UNITED STATES PATENT AND TRADEMARK OFFICE
CERTIFICATE OF CORRECTION

PATENT NO. : 7,018,871 B2
APPLICATION NO. : 10/642908
DATED : March 28, 2006
INVENTOR(S) : Cher Khng Victor Tan et al.

Fig. 7

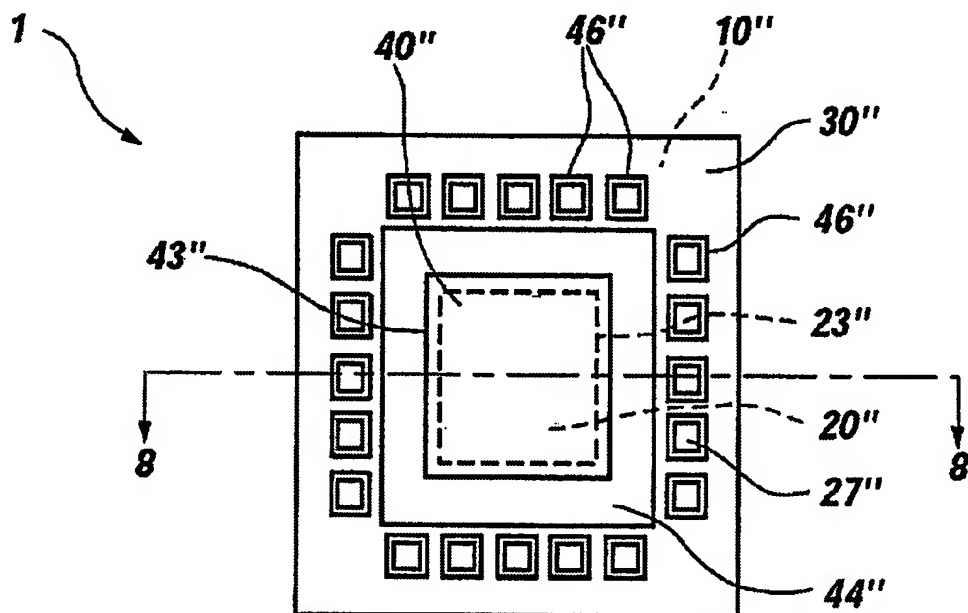
In FIG. 7,

move the dashed line square and associated
reference numeral 23" and associated lead line
to appear inside the solid line square labeled as
43" and change reference numeral " 22" "
to -- 20"--

Replace FIG. 7 with the following:

Fig. 10

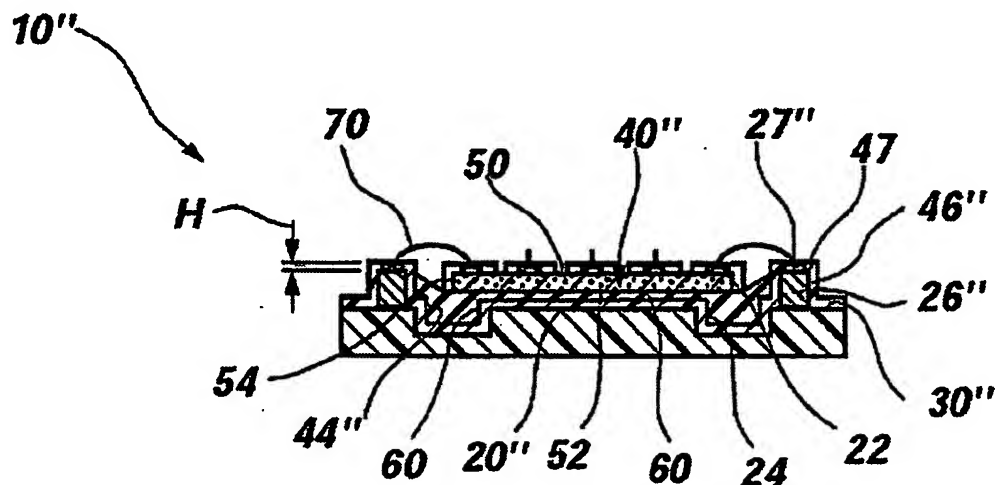
In FIG. 10,

redirect the lead line associated with reference
numeral 70 so that it rests at the top of the
curve to indicate the conductive element and
lengthen the lead line associated with reference
numeral 60 so that it stops within the adhesive
material appearing directly below device
securing region 40"

Replace FIG. 10 with the following:
